**MASTER PLAT
PEACHTREE MEADOWS**

PROJECT NUMBER: P2023-016
PROJECT NAME: Master Plat for Peachtree Meadows
SITE ADDRESS/LOCATIONS:

CASE CAPTION: Discuss and consider a request by Meredith Joyce on Michael Joyce Properties on behalf of John Vick of Qualico Development, Inc. for the approval of a Master Plat for the Peachtree Meadows Subdivision consisting of 292 single-family residential lots on a 140.50-acre tract of land identified as Tract 5 of the J. R. Johnson Survey, Abstract No. 128 and Tract 3 of the G. Wells Survey, Abstract No. 219, City of Rockwall, Rockwall County, Texas, zoned Planned Development District 101 (PD-101) [Ordinance No. 23-11] for Single-Family 10 (SF-10) District land uses, generally located on the southside of Mims Road west of the intersection of Mims Road and National Drive, and take any action necessary.

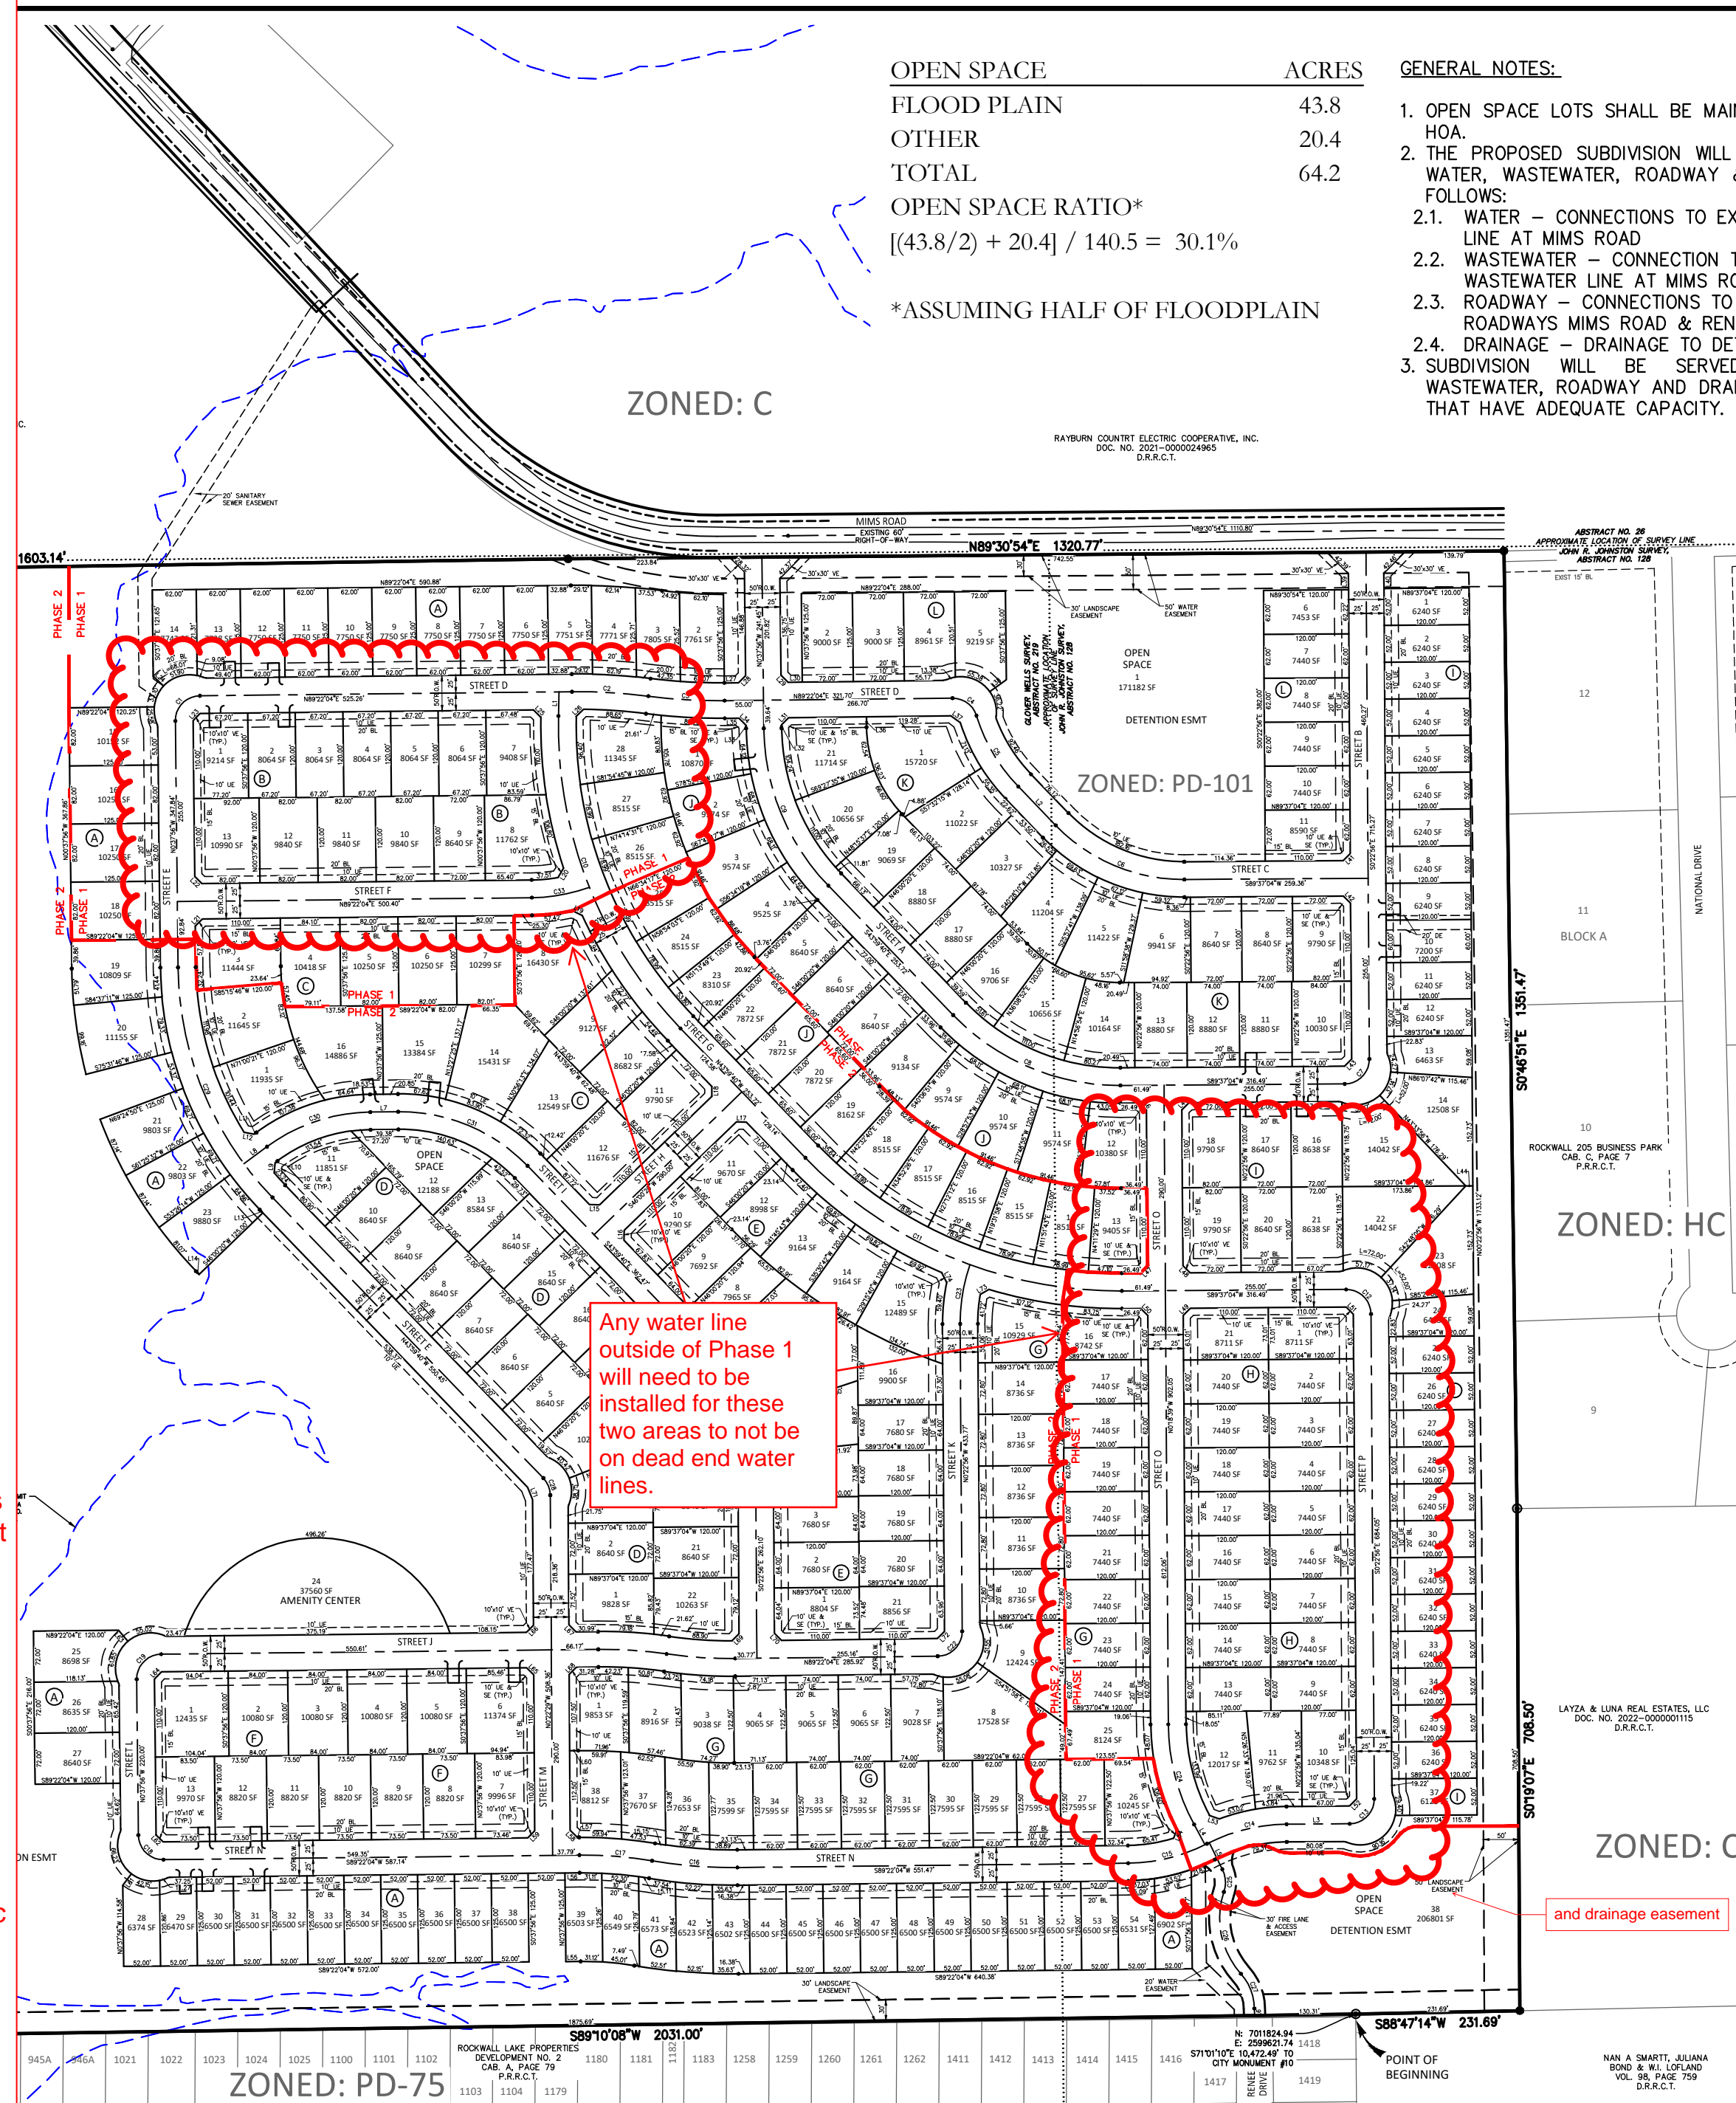
06/22/2023: - Any water line outside of Phase 1 will need to be installed for these two areas to not be on dead end water lines. (see markup)
- 50' Landscape and drainage easement.

3. Please show tree preservation bubbles on this plan

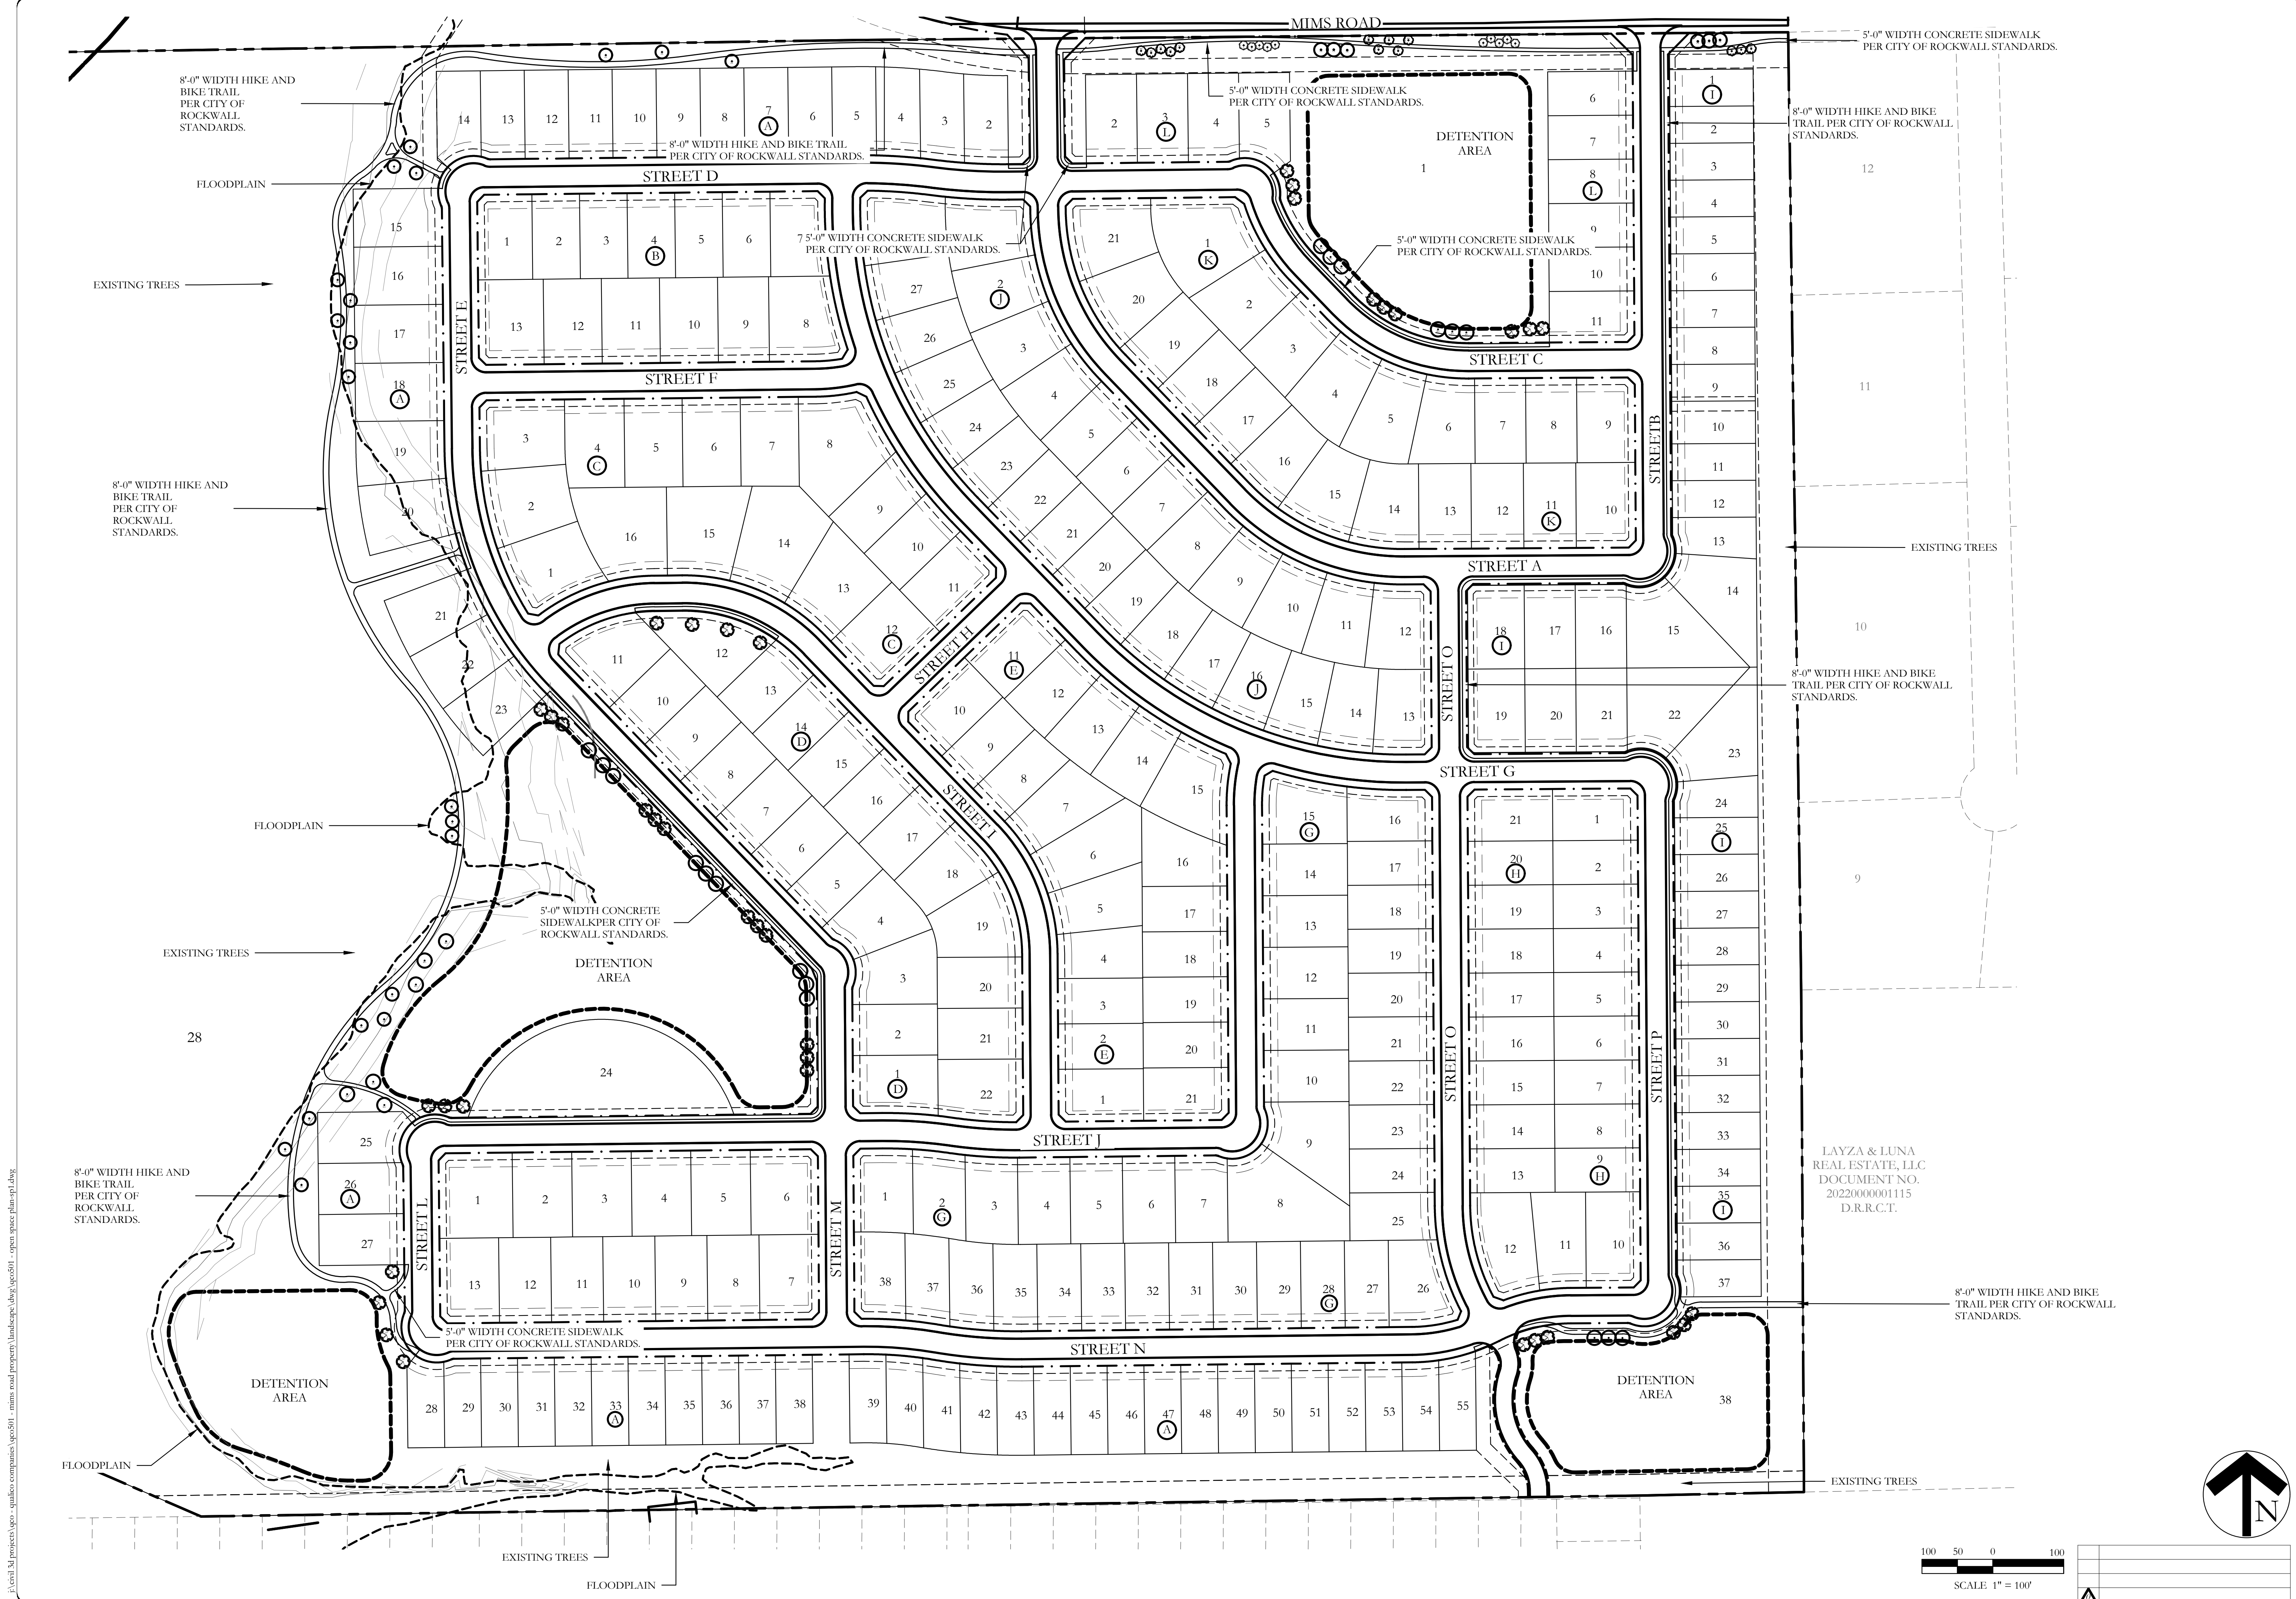
M.10 Open Space Master Plan (Section 38-7, Subdivision and Platting Procedures, of the Municipal Code of Ordinances):

- (1) Delineate the 30-foot tree preservation easement along the south property line.
- (2) Provide a color exhibit; have the different sidewalk/trail widths color coded.
- (3) Remove the landscaping.
